**Conditional Use Permit — Hotel — Holiday Inn
Express — Proposed Lot 1 Southport East Replat 15
— REV Development**

**CITY OF LA VISTA
PLANNING DIVISION
RECOMMENDATION REPORT**

CASE NUMBERS: PCUP23-0006;

RE: REV Development – PUD, CUP & Replat Applications – Initial Review Letter
Lots 5-6 Southport East

LANDSCAPE PLAN
LOT 1 CUP SUBMITTAL

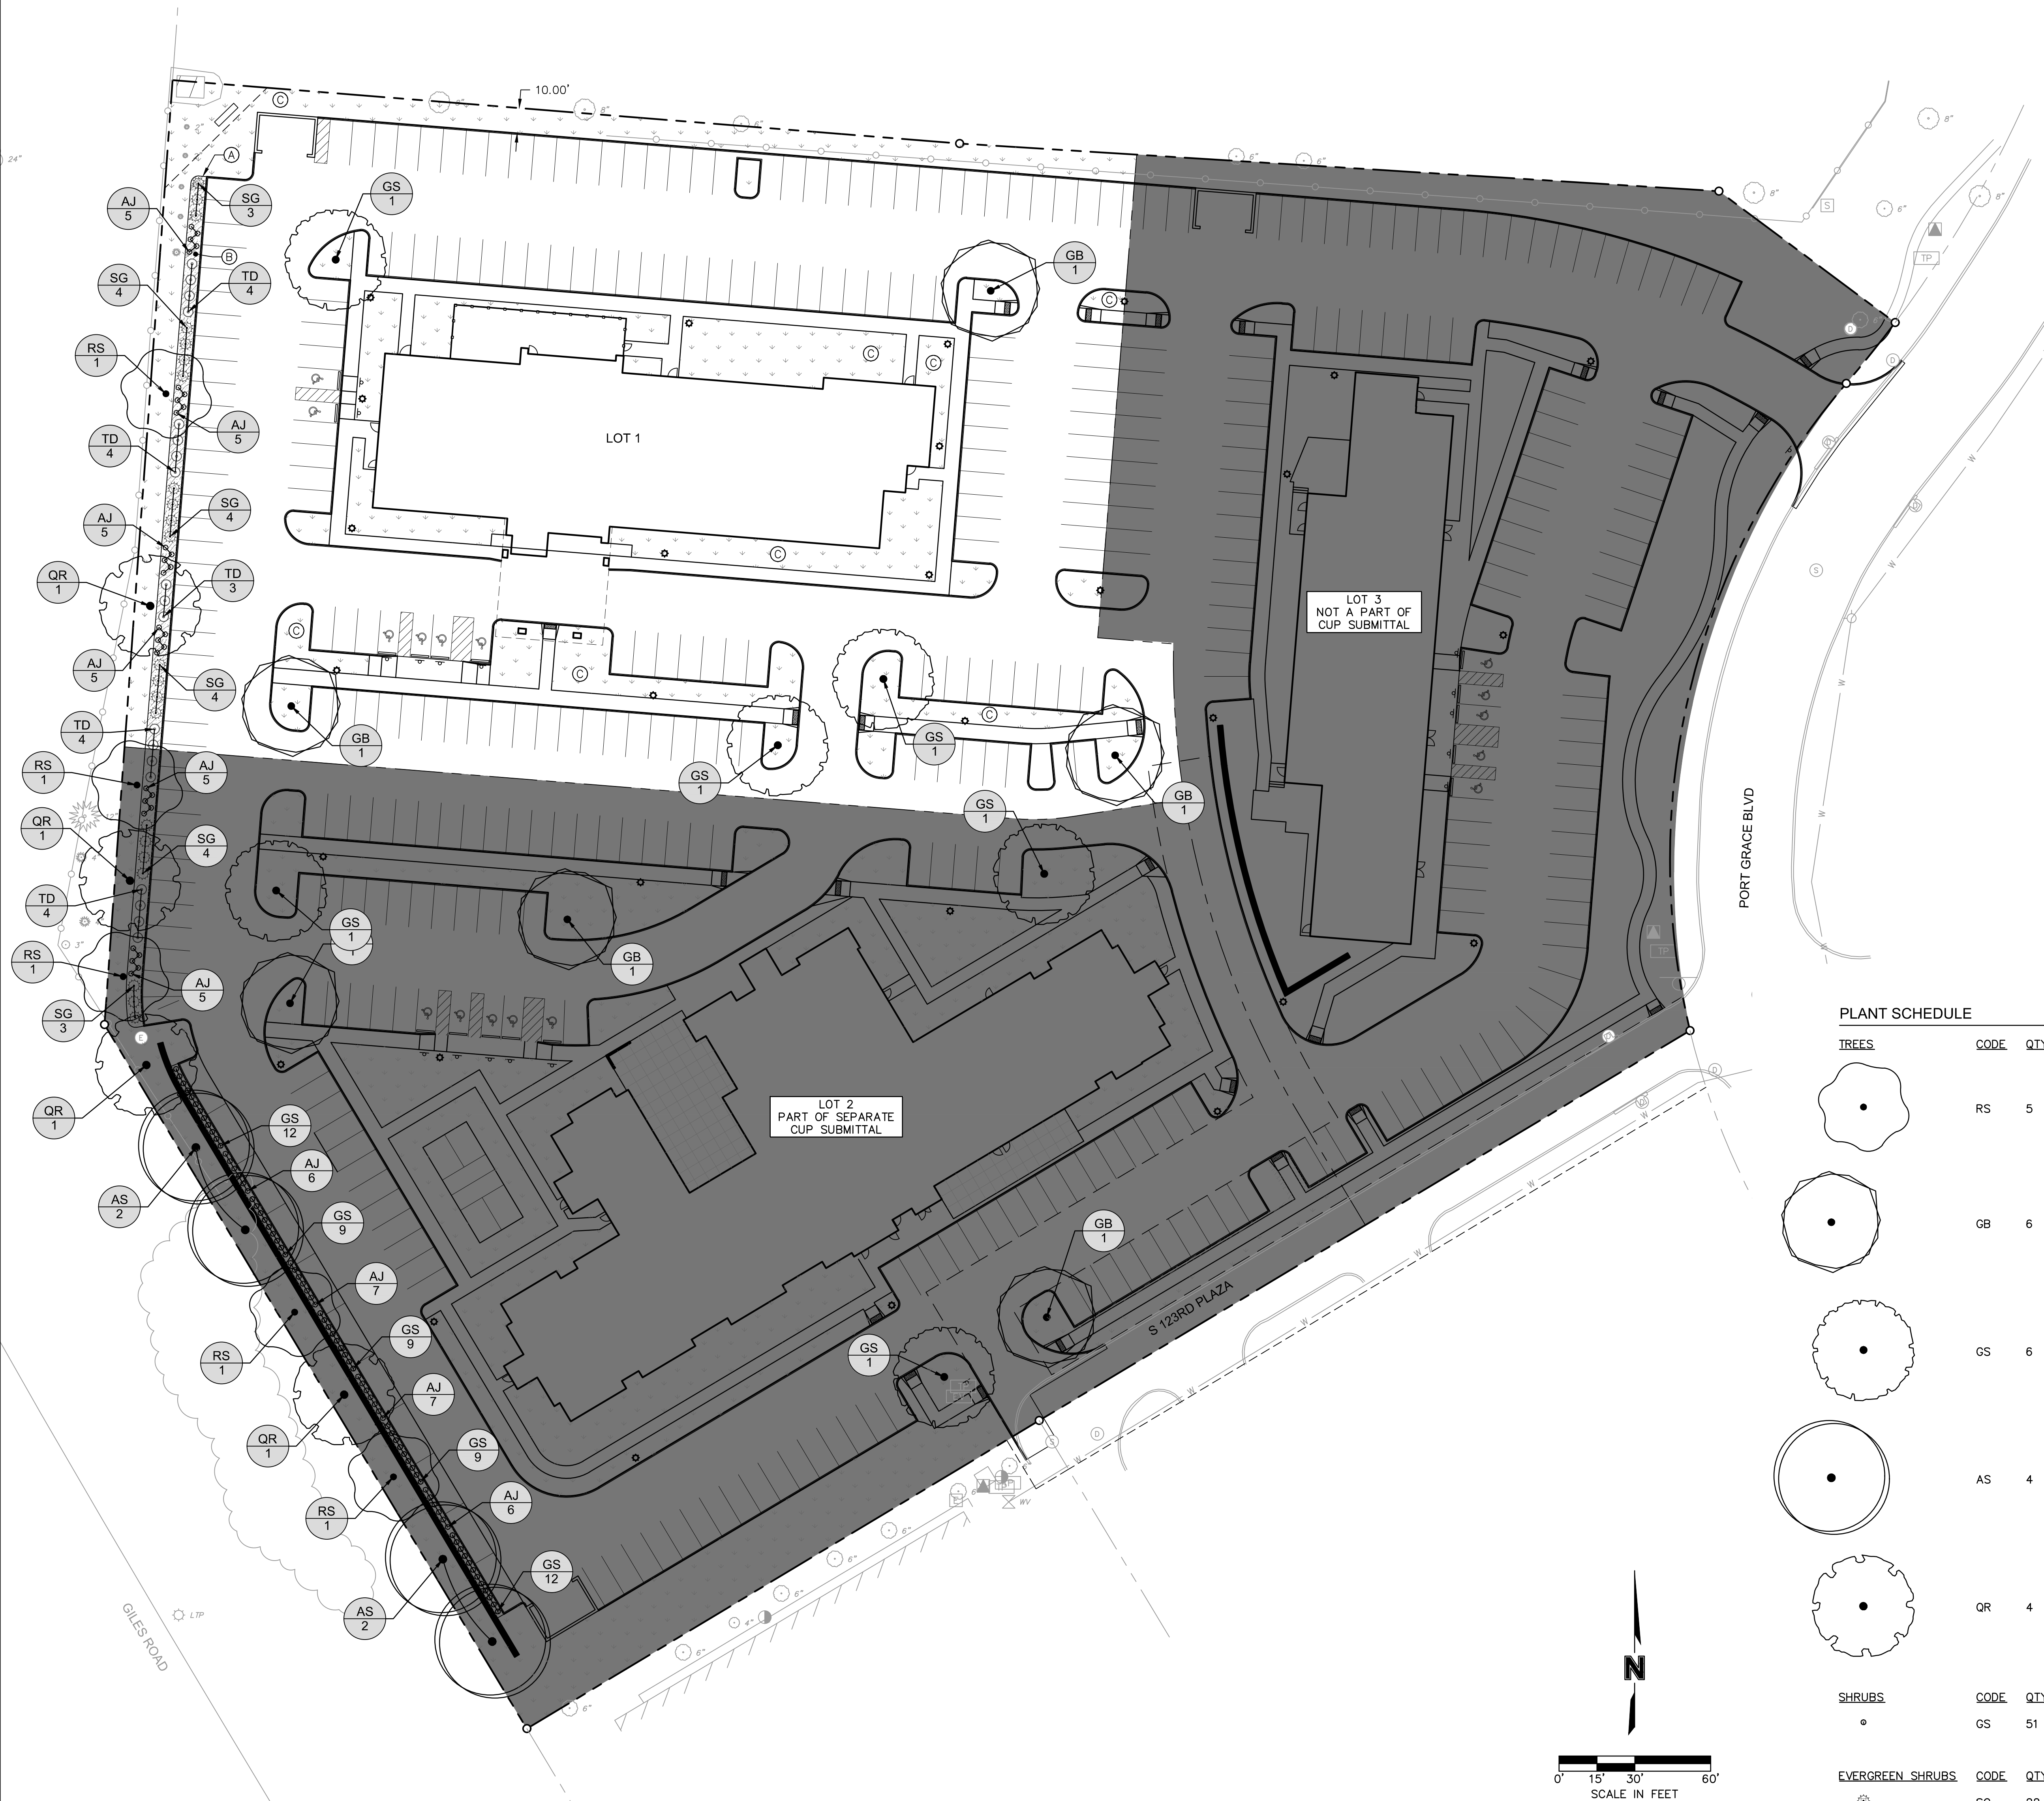
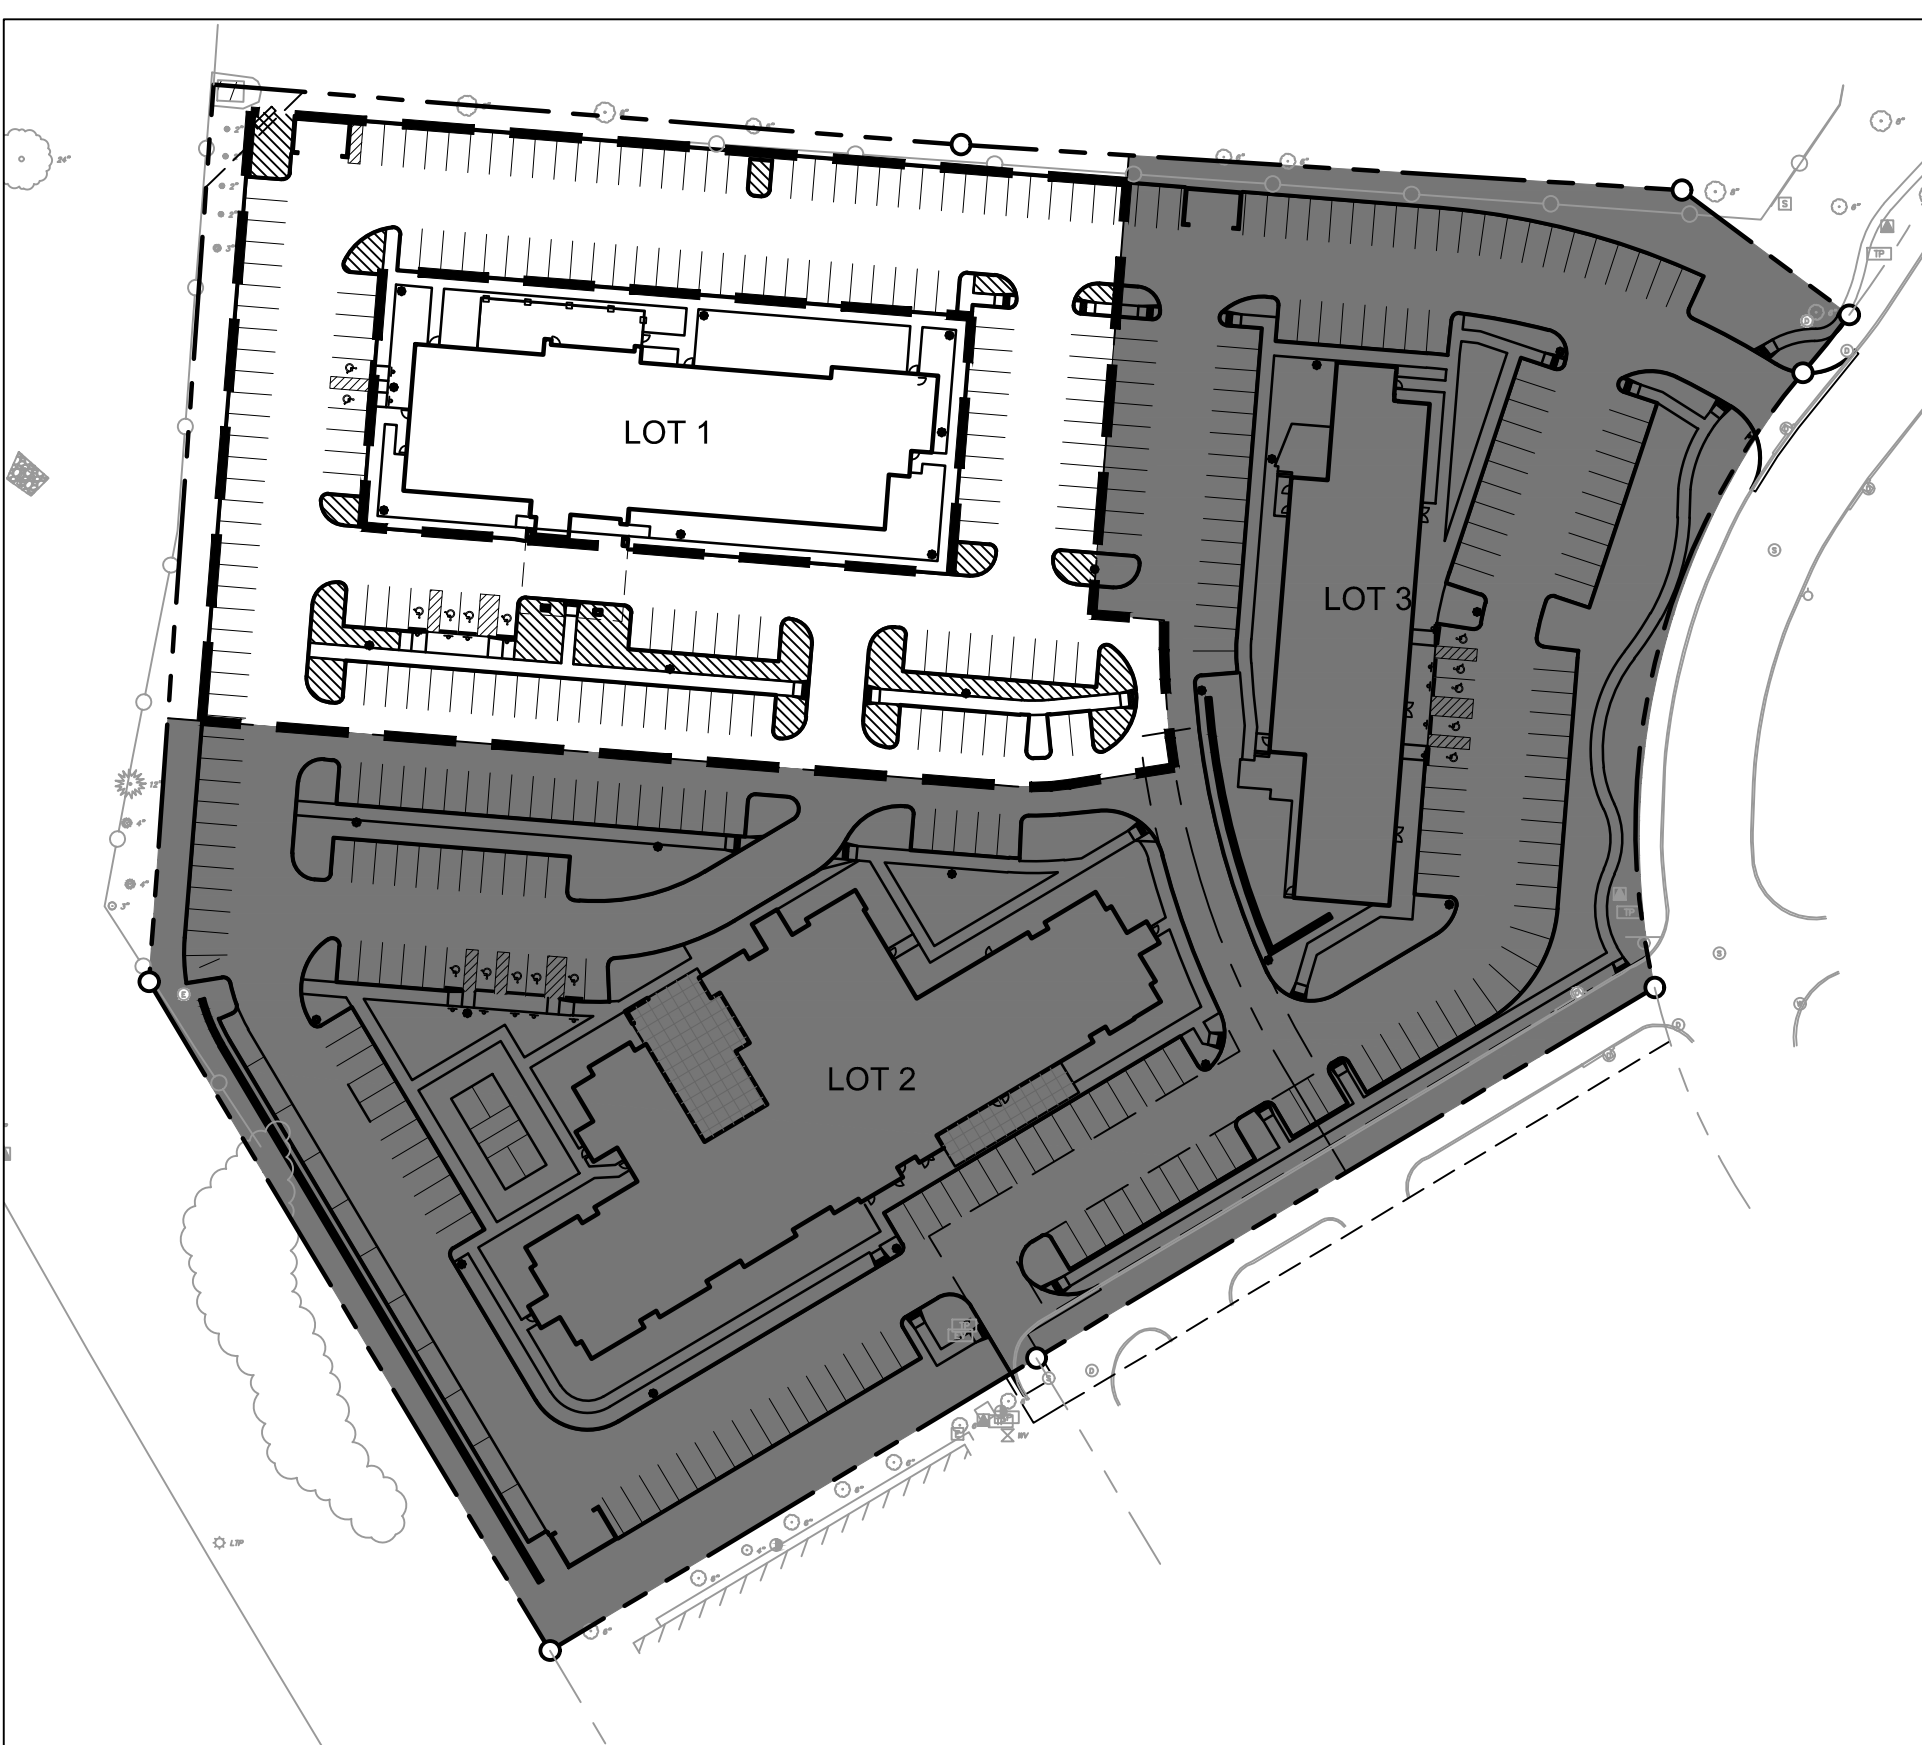
1. The following drawings were submitted:
 - a. L1.0 Landscape Plan
2. Additional reviews regarding landscaping will take place at the time of Design Review Submission for each building within this PUD with regard to specific requirements regarding the softening of areas around dumpster enclosures, screening of utilities, screening of mechanical equipment, etc.

1. Landscaping
 - i. No site dimensions are included to determine compliance with 6.1.D, which requires ten (10) foot wide landscaped, turfed (sodded or seeded) and irrigated green space along all interior lot lines shown in Appendix E.
 - ii. Per appendix G, the following proposed plants are not included in the approved list:
 1. Autumn Blaze Maple
 2. Bloodgood London Plane Tree
 3. Silver Linden
 4. Maney Juniper
 5. Karl Foerster Feather Reed GrassRevise to comply with Appendix G.
 - iii. Per Appendix G, trees shall have a minimum caliper of 3". Trees proposed on plant schedule have a caliper ranging from 2 to 2.5".
Revise to comply with Appendix G.
